**EAST GOSHEN TOWNSHIP
PLANNING COMMISSION
Meeting Agenda
Wednesday, February 1, 2017
7:00 PM**

SUBDIVISION AND LAND DEVELOPMENT PLAN
(PRELIMINARY/FINAL) FOR
BRAKMAN PROPERTY

SANITARY SEWER PROFILE AND DETAILS

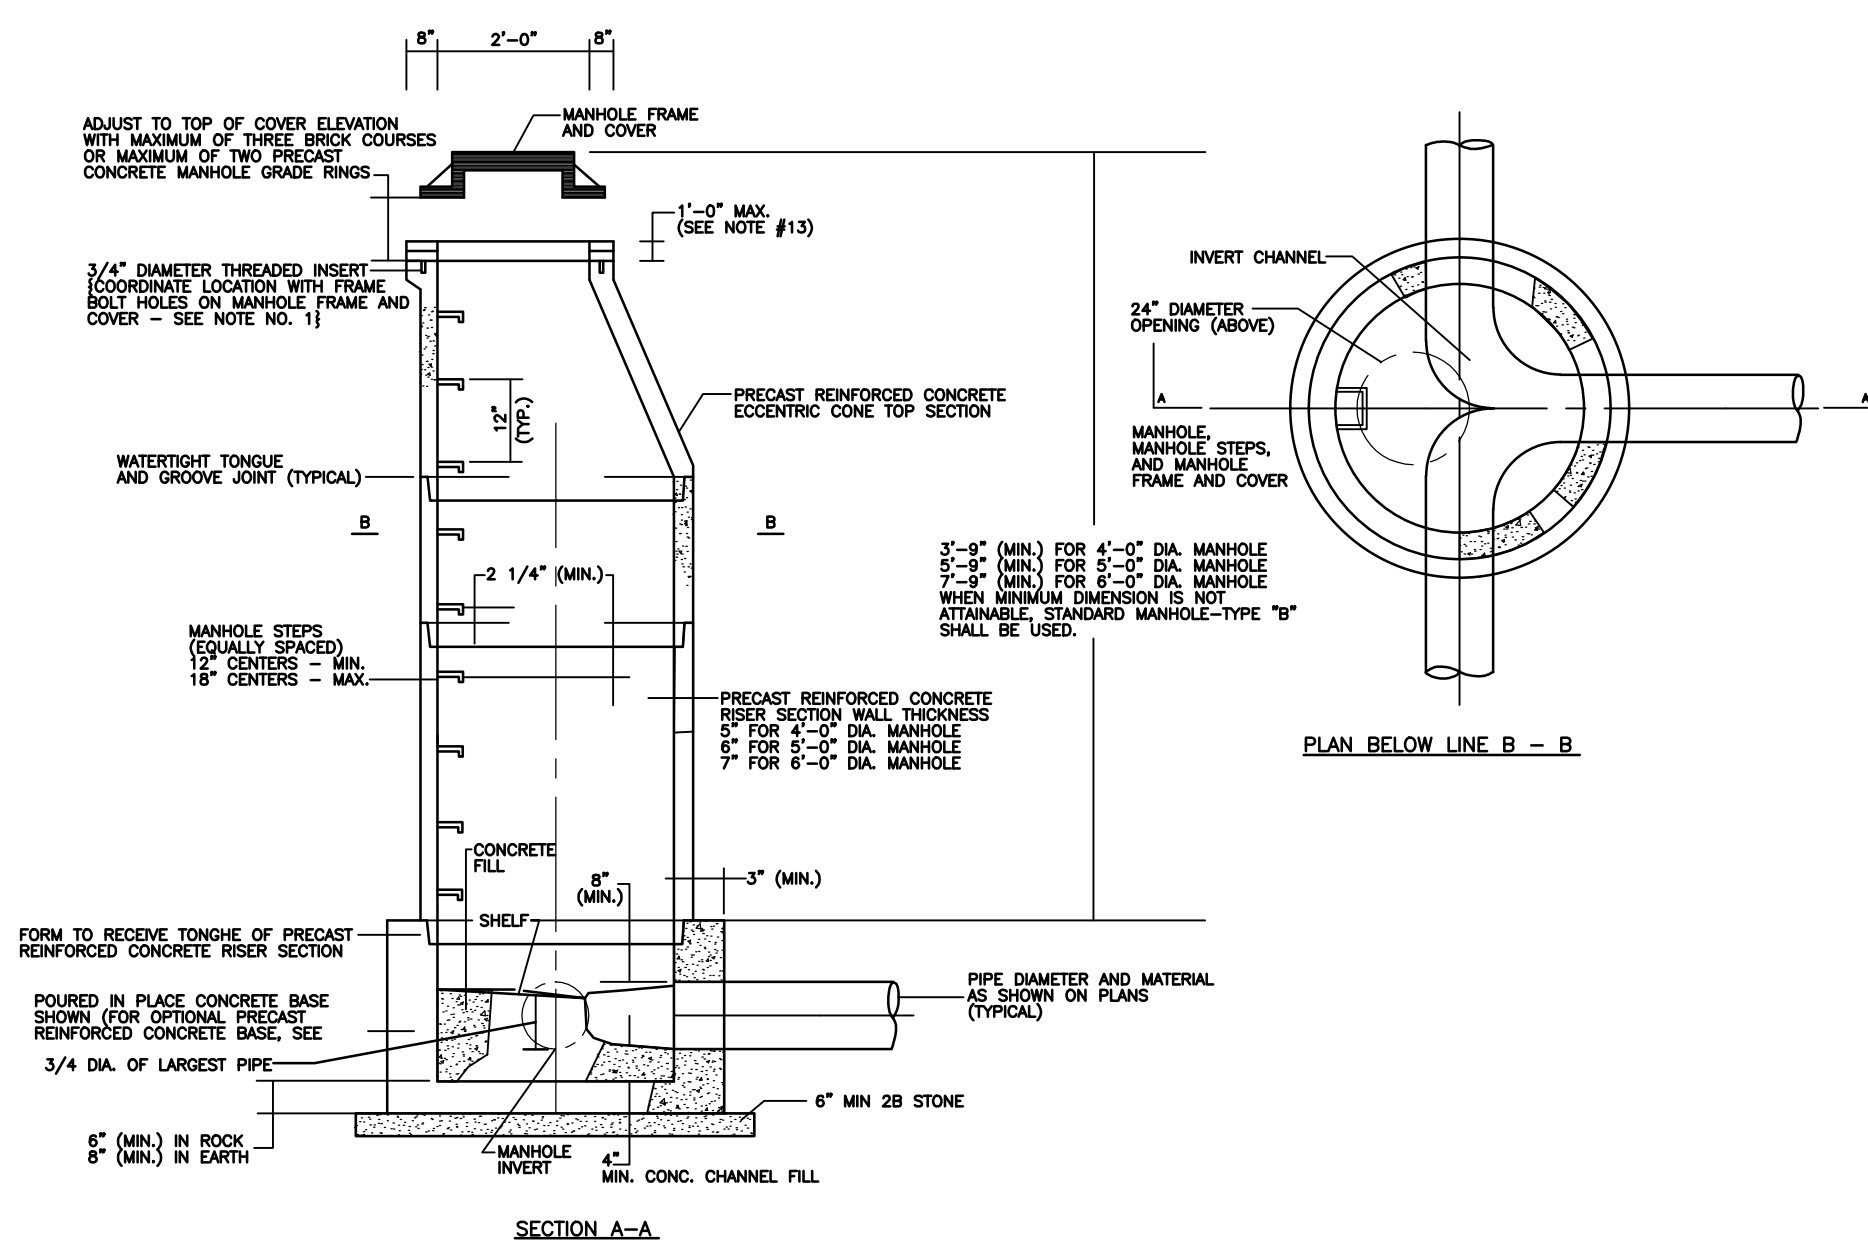
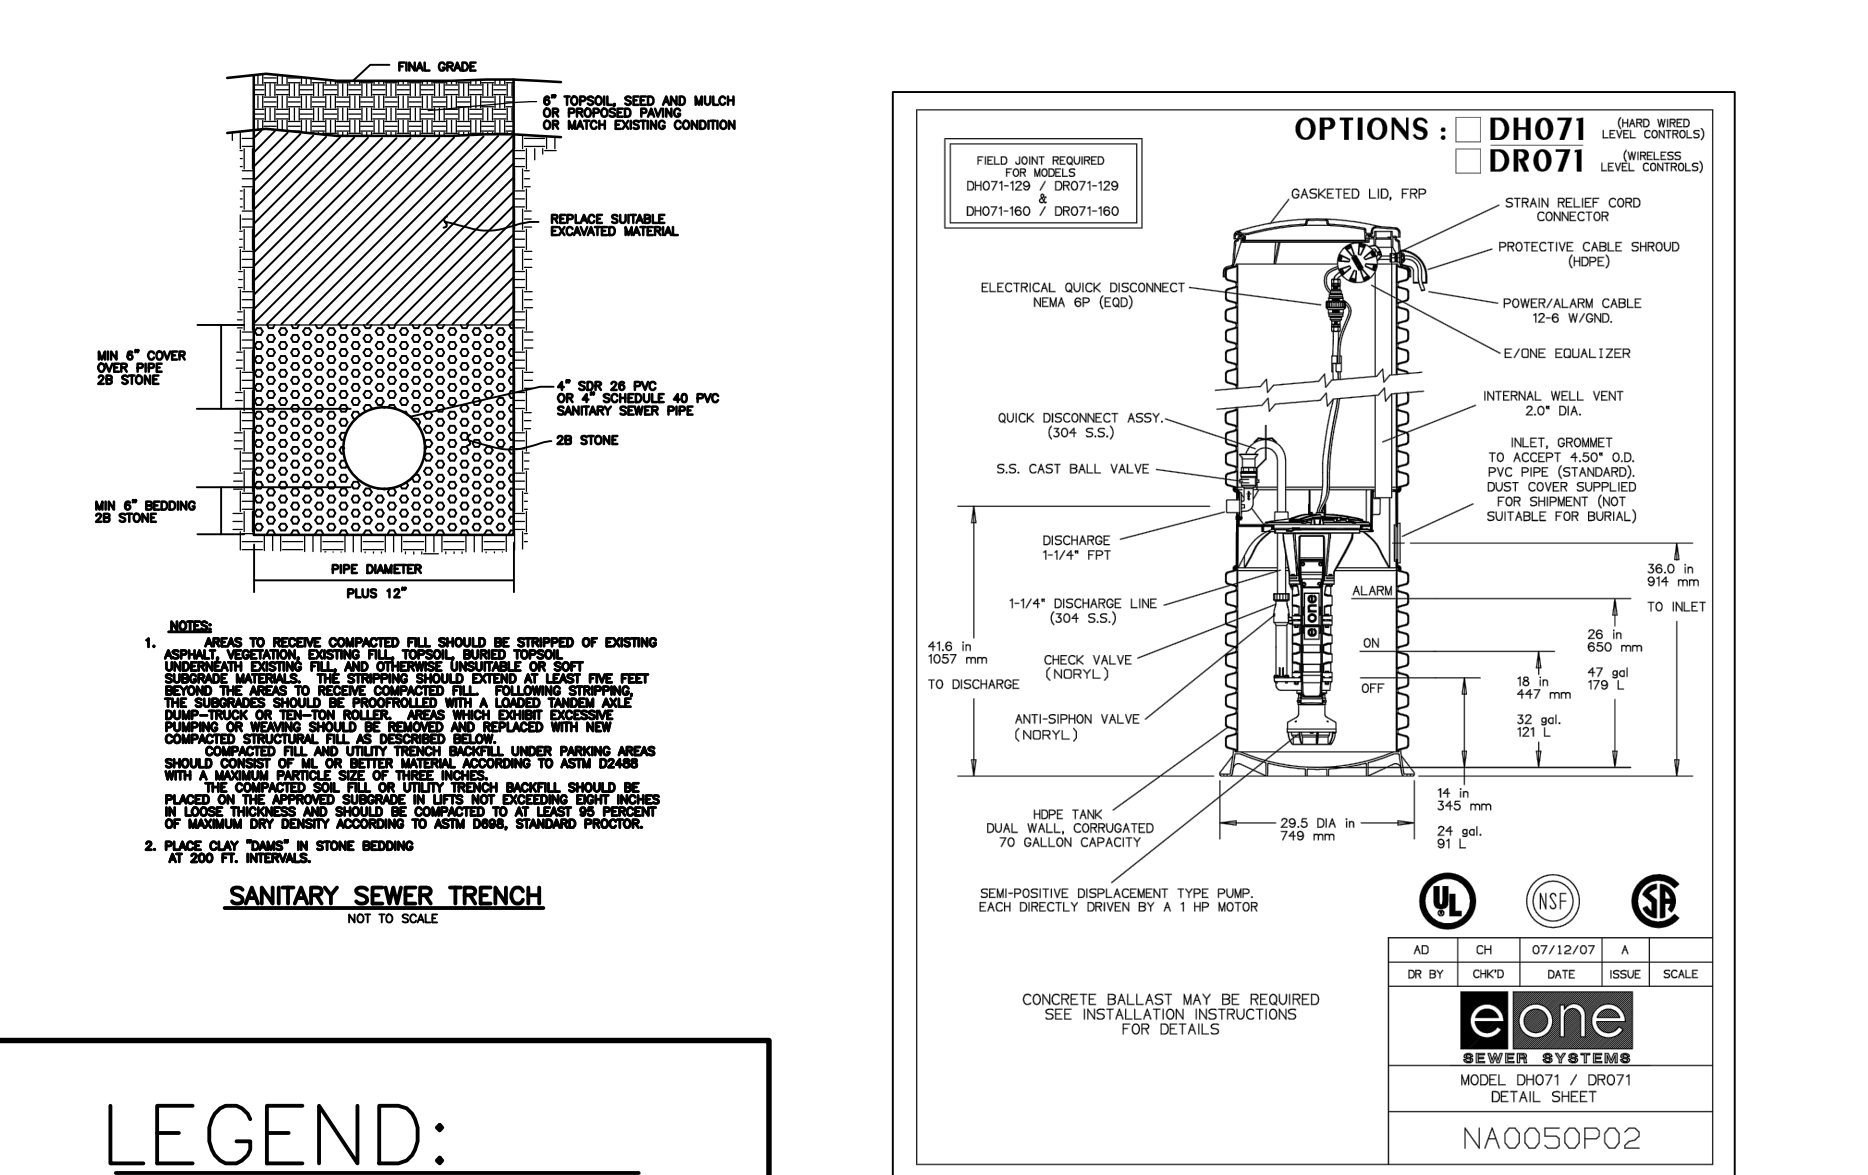
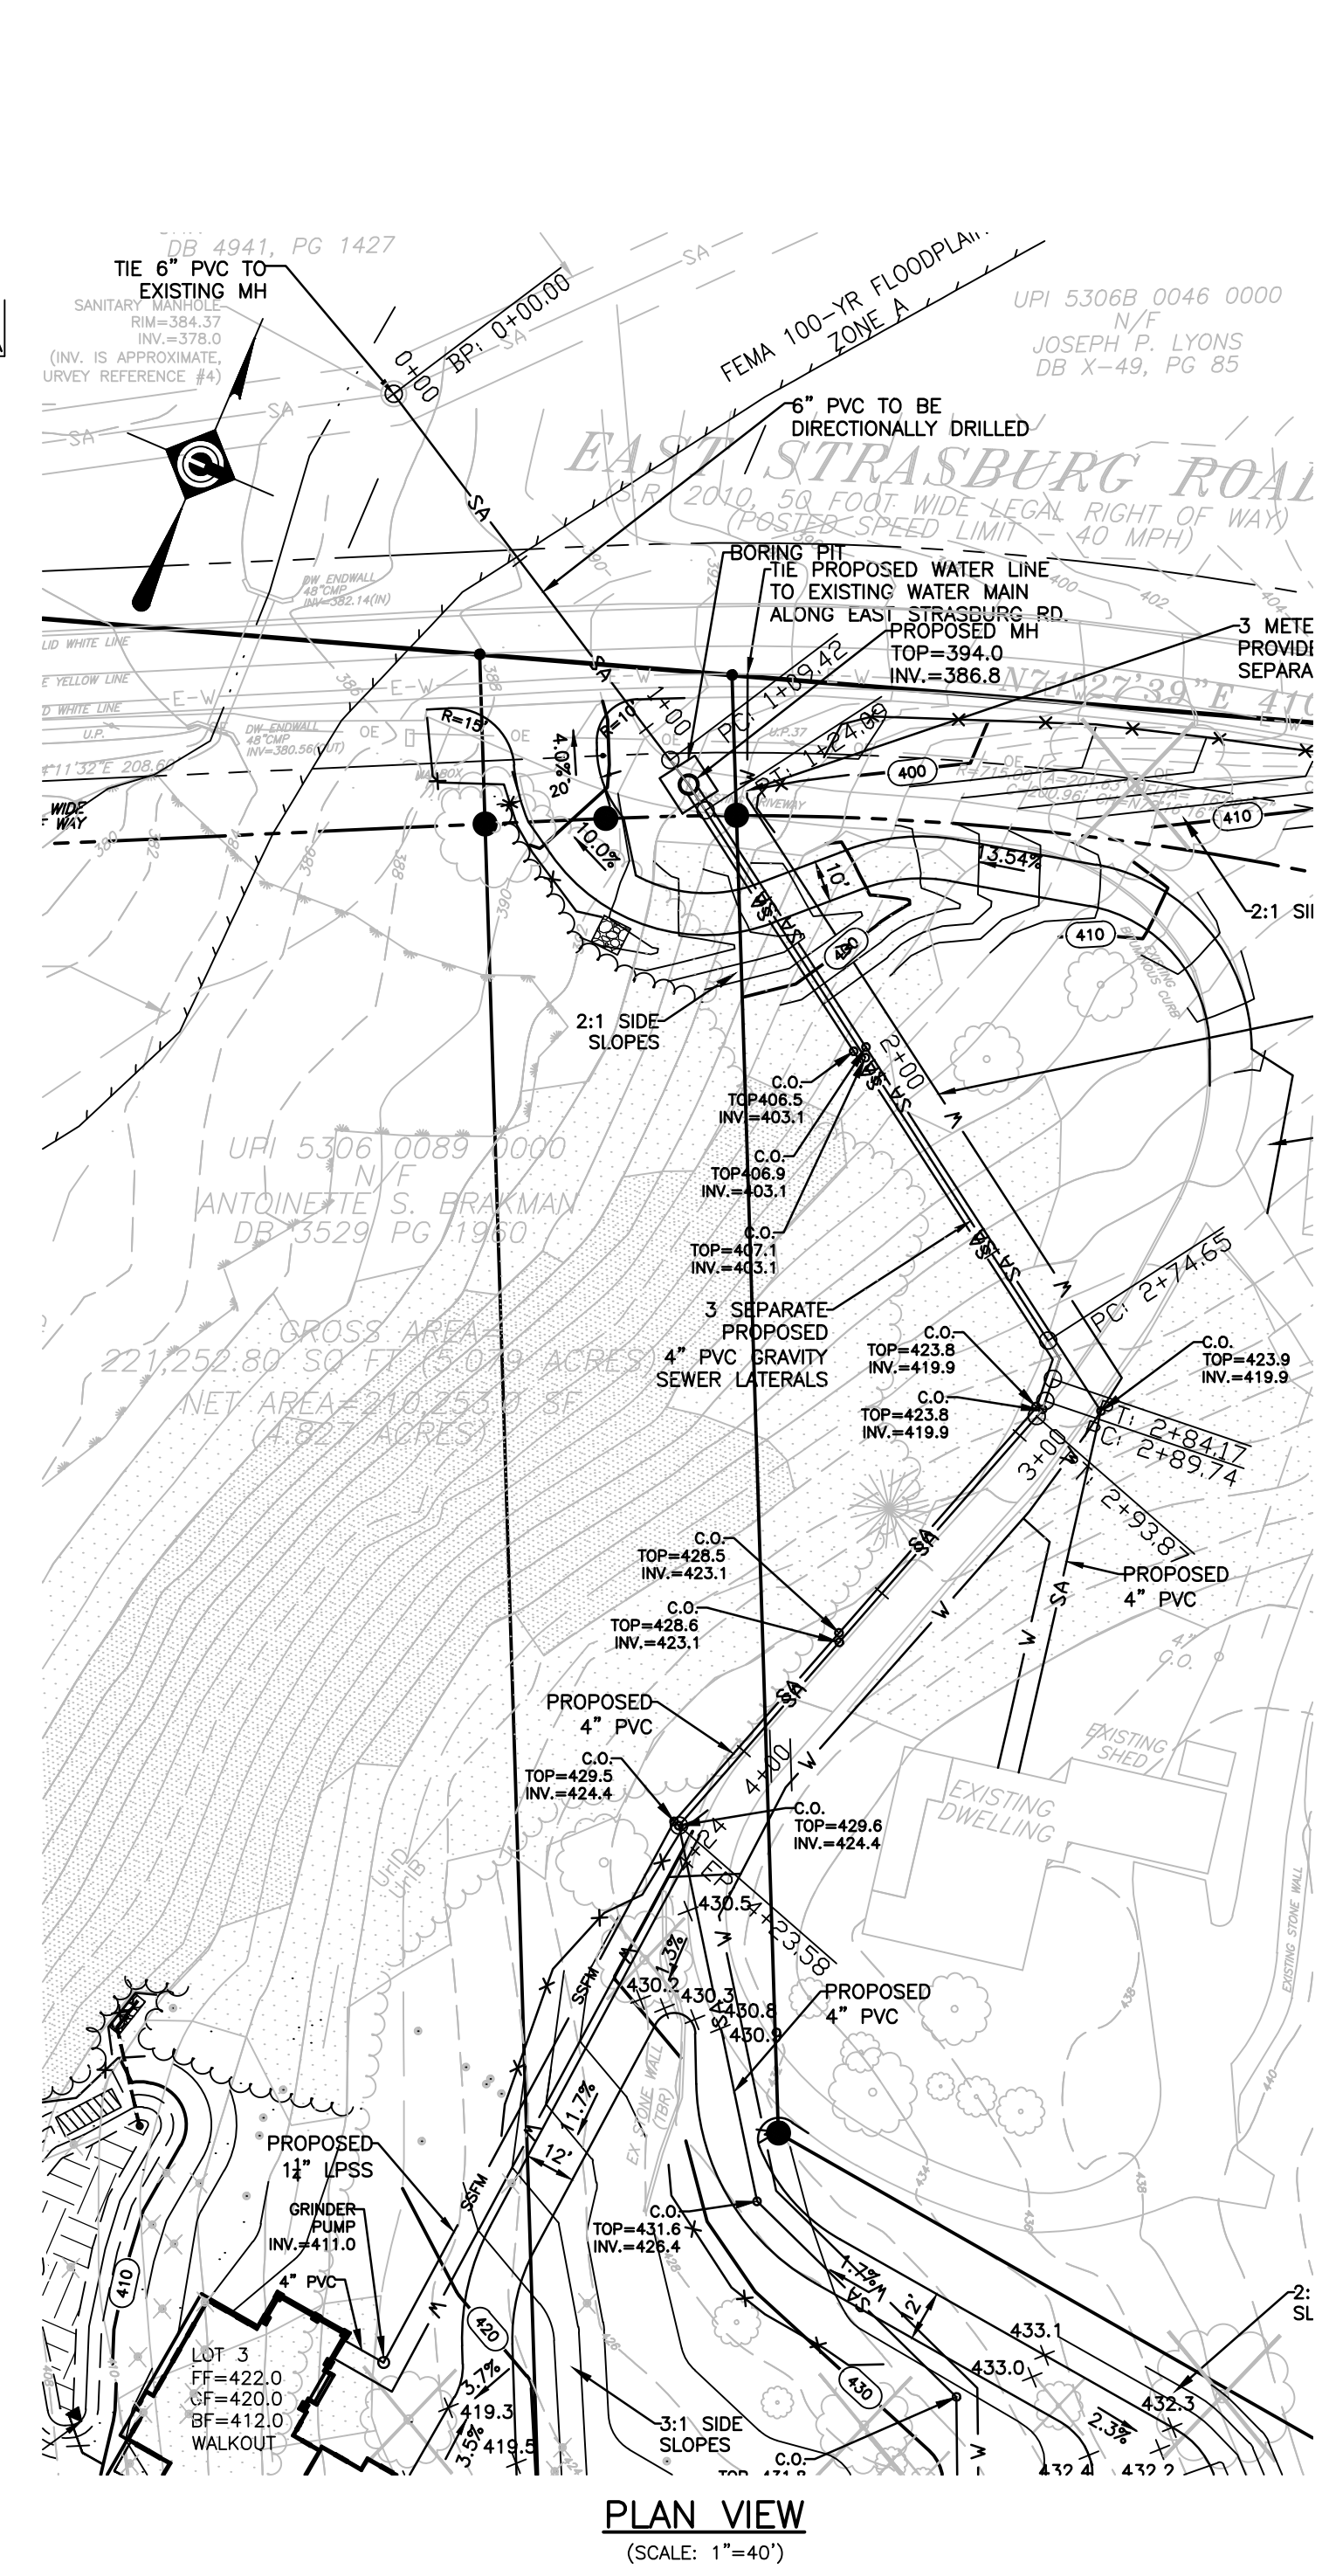
An additional manhole has been proposed on the subject property with Standard Manhole Detail Note #14 on Sheet 10 stating that any manhole receiving force main discharge should be lined with a PVC liner. For clarity, this note should call out the referenced manhole specifically and state that it shall receive a Duraplate-type PVC liner or approved equal.

Installation Note #3 has been added on Sheet 10 that all gravity sewer pipes should be installed as per §188-31.C. This note should also reference the "East Goshen Township Sewer Lateral/Building Sewer Detail" if not including the detail on this plans. We recommend that the detail be added to the plans to ensure compliance.

- j. The profile view (Sheet 10) indicates that the existing water main has less than 3 feet of cover. We understand this is the depth at which Aqua believes the main MAY be located. The Applicant should consider installing the sewer main a little deeper at this location to minimize the risk of a conflict, specifically since the new manhole may not be deep enough to address such a conflict.

9. The following comments are in regards to the new Standard Manhole detail and notes on Sheet 10:
 - a. The manhole cover adjustment note should only reference precast grade rings; the reference to bricks should be deleted.

16. A note labeled as "Installation Note" has added to Sheet 10.
17. A utility easement on the Kaplan property is required as indicated on the plans.
17. The utility easement has been revised accordingly per the revised sanitary sewer design.

19. The above information has been included as part of the note labeled as "Installation Note" on Sheet 10.
20. We recommend the inclusion of additional details or notes regarding the gravity sewer lateral from the house to the grinder pump including, at minimum, pipe material, size, cleanout, trap, and vent cap.
20. Details and notes (under "Installation Notes") have been added to Sheet 10. Also, cleanouts have been added to all gravity sewers as appropriate.
